Submit 1 Copy To Appropriate District Office	State of New Mexico	Form C-10		
<u>District I</u> – (575) 393-6161	Energy, Minerals and Natural Resources	Revised July 18, 20		
1625 N. French Dr., Hobbs, NM 88240 District II – (575) 748-1283		WELL API NO.		
$\frac{D1SUICUM}{1} = (373) 748-1283$ 811 S. First St., Artesia, NM 88210	OIL CONSERVATION DIVISION	<u>30-015-44754</u>		
District III - (505) 334-6178	1220 South St. Francis Dr.	5. Indicate Type of Lease		
1000 Rio Brazos Rd., Aztec, NM 87410 District IV - (505) 476-3460	Santa Fe, NM 87505	6. State Oil & Gas Lease No.		
1220 S. St. Francis Dr., Santa Fe, NM	· · · · · · · · · · · · · · · · · · ·	0. State On & Gas Lease No.		
87505				
	TICES AND REPORTS ON WELLS OSALS TO DRILL OR TO DEEPEN OR PLUG BACK TO A	7. Lease Name or Unit Agreement Name		
	JCATION FOR PERMIT" (FORM C-101) FOR SUCH	Spud Muffin 31-30		
PROPOSALS.)		8. Well Number 735H

1. Type of Well: Oil Well	Gas Well 🛛 Other			
2. Name of Operator	ON ENERGY PRODUCTION COMPANY, LP.	9. OGRID Number 6137		
3. Address of Operator	ON ENERGY PRODUCTION COMPANY, LP.	10. Pool name or Wildcat		
	WEST SHERIDAN AVENUE, OKC, OK 73102	(98220) PURPLE SAGE; WOLFCAM

4. Well Location

WELL LOCATION AND ACREAGE DEDICATREGENED

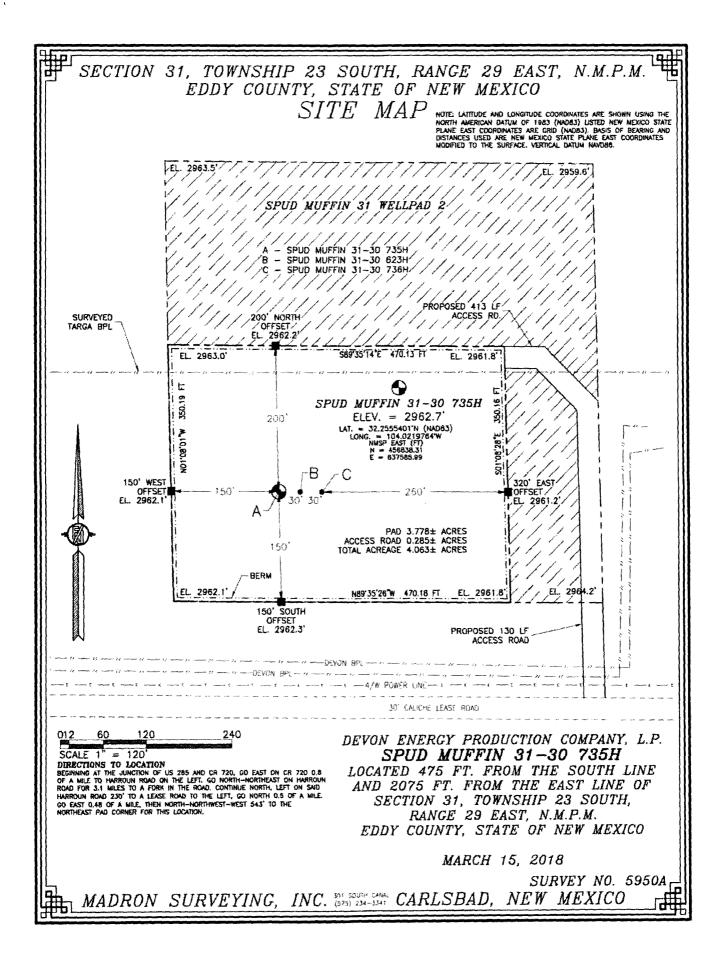
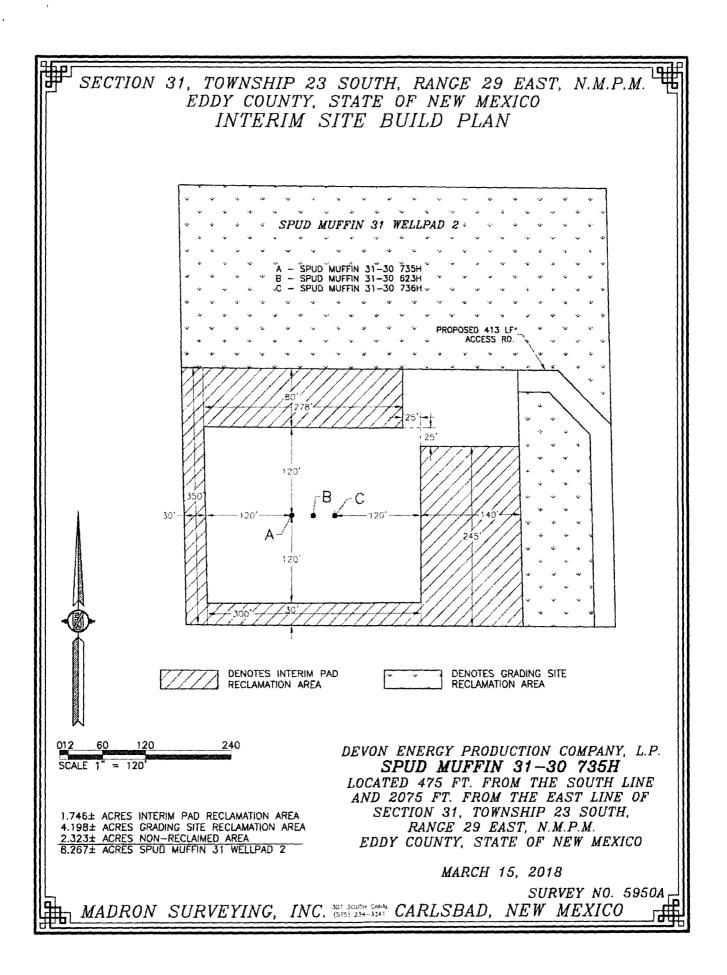
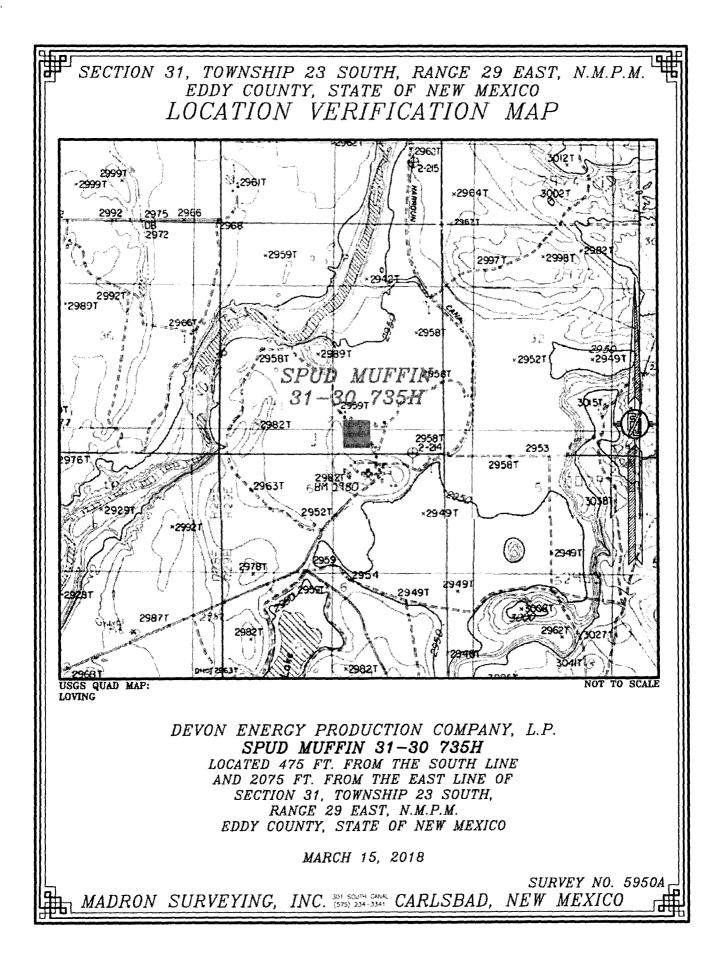
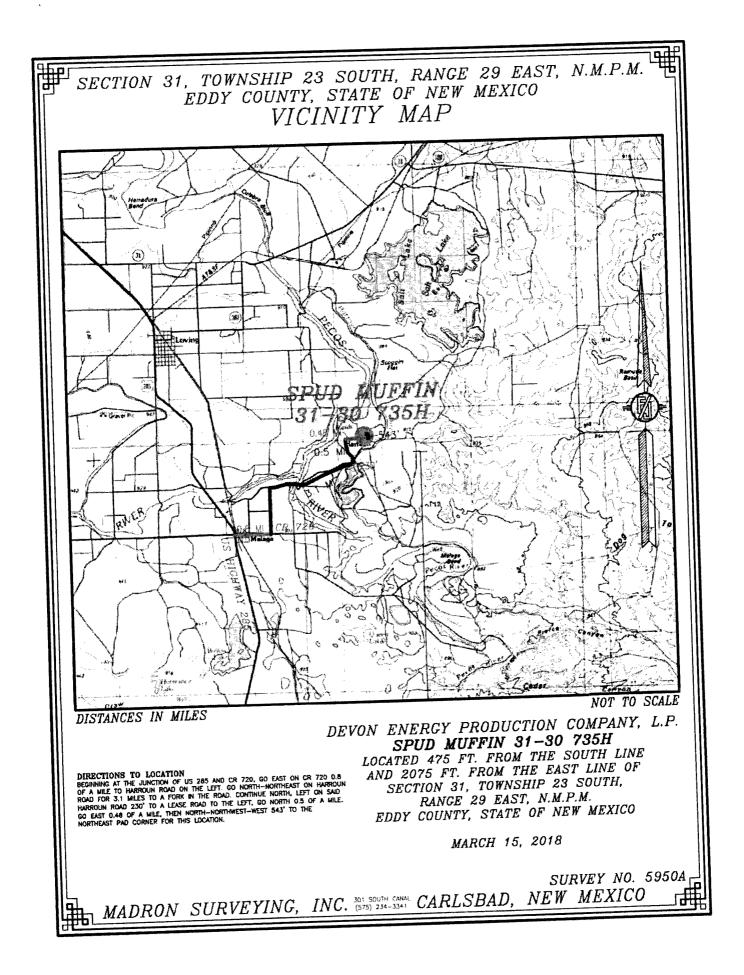
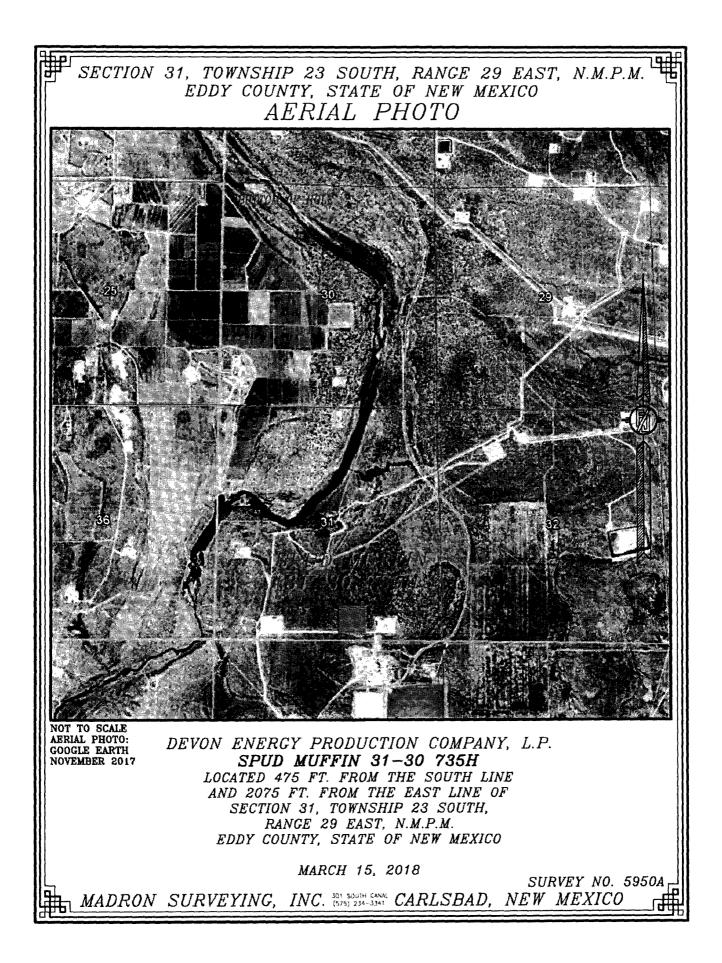
13. Describe proposed or comof starting any proposed we proposed completion or reduced by proposed completion or reduced by per the following: FROM Sec. 30, T23S, R29E TO Sec. 30, T23S, R29E ATTACHMENT: Ferrit Antipartic based on the section of the sectio	npleted operations. (Clearly state all pertinent details, a work). SEE RULE 19.15.7.14 NMAC. For Multiple C ecompletion. uction Company, LP Respectfully requests 2630 FSL/2310 FEL 230 FNL/2310 FEL Revised C-102 <i>pTP</i> , 208/2/MP. on above is true and complete to the best of my knowled MAMMA	approval to change the Bottom Ho approval to change the Bottom Ho NM OIL CONSERVATION ARTESIA DISTRICT APR U3 2018 RECEIVED IOTEOTUD Ige and belief. iance AnalystDATE04.03.18 omPHONE: (405)552-7970

LTP 330' FNL & 2310' FEL	
$\begin{array}{l} \text{NUSP EAST} (1)\\ \text{N} = 457039.80\\ \text{E} = 634382.44\\ \text{W} = 0 \text{ CORNER SEC. 30}\\ \text{LAI.} = 32.2762567\text{N}\\ \text{LONE.} = 104.0322231\text{W}\\ \text{NNSP EAST} (1)\\ \text{N} = 46365.65\\ \text{E} = 634386.03\\ \end{array}$	$\begin{array}{c ccccccccccccccccccccccccccccccccccc$	OPERATOR CERTIFICATION Inserting should be information constanted herein as true and complete its the best of my knowledge used being, and thus this ingunitation entries owns a voorking interest or undeased minered interest in the land including the program between hole boostion or has a right to defil this well at this however pursuant to: a contrast with an owner of vach is minered or working interest, or los a vooluntery providing agreement or a compulsion people's onler heredofine entered by the dissilien. by the dissilien Base Erin Workman Printed Name

FTP 330' FSL & 2310' FEL
